GINZBURG, Boris et al.

10/705,983

REMARKS

Drawings Rejections

FIG. 1

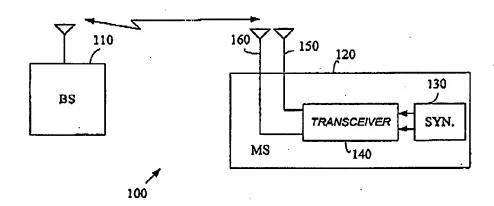
The drawings have been objected to for "failing to comply with 37 CFR 1.84 (p) (4) because reference characters "120" and "200" have both been used to designate a mobile station; reference characters "130" and "300" have both been used to designate dual output synthesizer; reference characters "140" and "250" have both been used to transceiver; reference characters "150" and "260" have both been used to designate a first antenna; reference characters "160" and "270" have both been used to designate a second antenna."

The recitation in block 140 "TRANSCIEVER" is objected to as improper; it is suggested by the Examiner to be changed to "TRANCEIVER". The drawings are objected to as failing to comply with 37 CFR 1.84 (p) (5) because they do not include the following reference sign(s) mentioned in description: "225" and "235".

Regarding the Examiner's comments as to the seeming discrepancies between Fig. 1, and Fig. 2, it is respectfully submitted that the elements are numbered differently so as to emphasize that Figs. 1 and 2 may represent different embodiments of the invention. Accordingly, for example, transceiver 140 in one embodiment may be of a different configuration than the transceiver 300 depicted in the embodiment of Fig. 2. Likewise, mobile station 120 may be different from the embodiment of mobile station 200 depicted in Fig. 2. Accordingly, Applicants respectfully request that the objection be withdrawn.

In Fig. 1, "TRANSCEIVER" has been corrected; in Fig. 2, item numbers 225 and 235 have been inserted, and "FRACTIONAL" has been corrected.
